# HISTORIC AND DESIGN REVIEW COMMISSION

October 06, 2021

**HDRC CASE NO:** 2021-481  
**ADDRESS:** 301 ALAMO PLAZA  
**LEGAL DESCRIPTION:** NCB 423 BLK 24 LOT S IRRG 69.18 FT OF 14 OR A8  
**ZONING:** D, H  
**CITY COUNCIL DIST.:** 1  
**DISTRICT:** Alamo Plaza Historic District  
**APPLICANT:** Andi Rodriguez/Centro San Antonio  
**OWNER:** Frank Ruttenberg/H E SAN ANTONIO I L L C  
**TYPE OF WORK:** Mural installation  
**APPLICATION RECEIVED:** September 09, 2021  
**60-DAY REVIEW:** Not applicable due to City Council Emergency Orders  
**CASE MANAGER:** Rachel Rettaliata

The applicant requests a Certificate of Appropriateness for approval to install a mural on the west elevation of 301 Alamo Plaza.

123 Losova

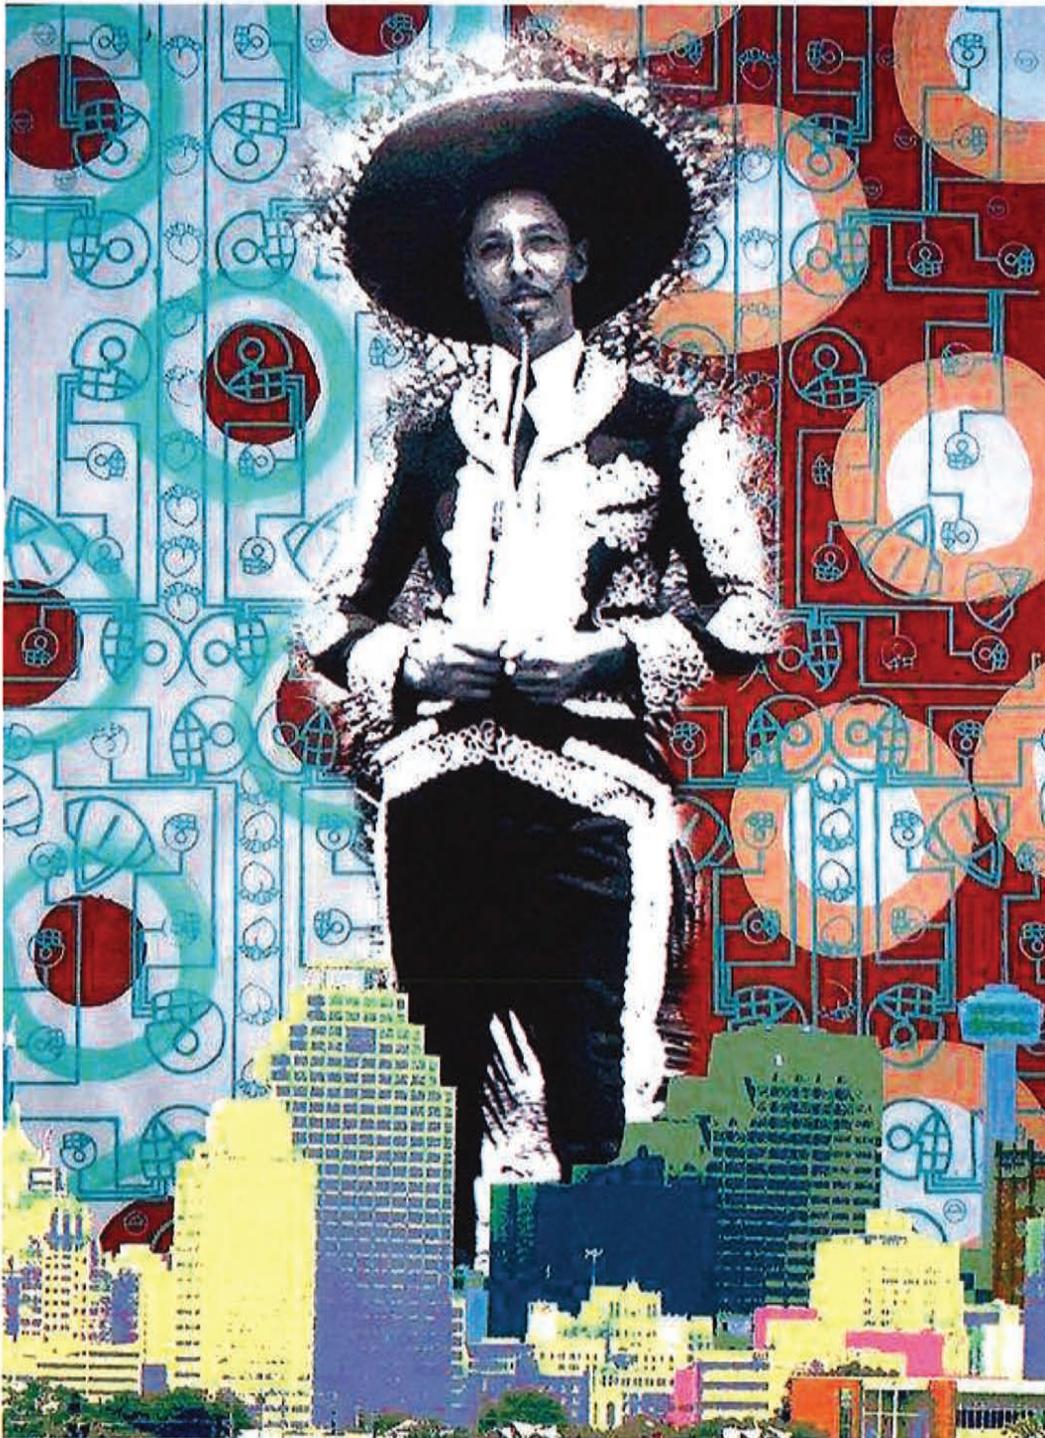
- b. **PUBLIC ART** – The applicant has proposed to install a mural on the west (rear) elevation of the structure. The mural proposed is "The West Side" by Luis Valderas. The mural features three mariachis from the past with a backdrop of San Antonio's future. The mural may be as large as 12' x 30' feet. Composition of the piece is proposed as artwork on a removable substrate which will not harm the environment nor the building; this mural is temporary and can be removed at the owner's request. Staff finds the proposal appropriate.

- c. **MURAL INSTALLATION** – The applicant is requesting to install a public mural that will be painted offsite on a substrate material that will be installed on the brick. Previous mural installations on brick have been approved to use Polytab, a non-woven fabric that is commonly part of large public mural art projects. Polytab is applied to masonry often using Nova Gel and squeegeed to the surface. A gel coated is generally applied at the edge seams to create a seamless effect. The Polytab can be easily removed using hand tools with minimal, if any, damage to the existing brick. Centro has proposed to install the mural on a thin vinyl substrate similar to Polytab, that does not need to be primed with multiple coats of acrylic, as it is already weatherproof and provides a cleaner removal of the material and adhesive. Centro has proposed to use eco-friendly ink and adhesive that will not contain petroleum solvents. As the proposal does not include painting the exterior historic brick façade, staff finds the proposal consistent with the Historic Design Guidelines but finds that final product specifications for the substrate should be submitted to staff for review.

- d. According to the Secretary of the Interior's Standards for Rehabilitation, historically unpainted brick should not be painted. Brick structures built prior to the 1870s were largely constructed of handmade bricks, which were generally softer, more porous, and weaker than bricks made at the turn of the 20th century. These handmade bricks were frequently painted or coated because the strength of the brick was insufficient without a coating for stabilization. However, as machine-made bricks became the standard during the latter half of the 19th century, bricks became inherently stronger and did not require paint or coatings for protection and strength. These bricks commonly featured harder "dress" surfaces, which were meant to face the exterior of the structure and remain unpainted. Painting historically unpainted brick on structures of this era can lead to trapped water in the porous material, eventually destroying the brick due to the damaging effects of water infiltration and freeze-thaw cycles. The existing brick on the east façade was formerly a parti-wall that was devoid of ornamentation. Staff finds modifications to non-primary facades and parti-walls appropriate and finds that the proposed temporary mural and paint product on a removable substrate will not negatively impact the integrity of the existing masonry.

- i. That the applicant submits final product specifications for the proposed substrate to staff for review and approval prior to the issuance of the Certificate of Appropriateness.
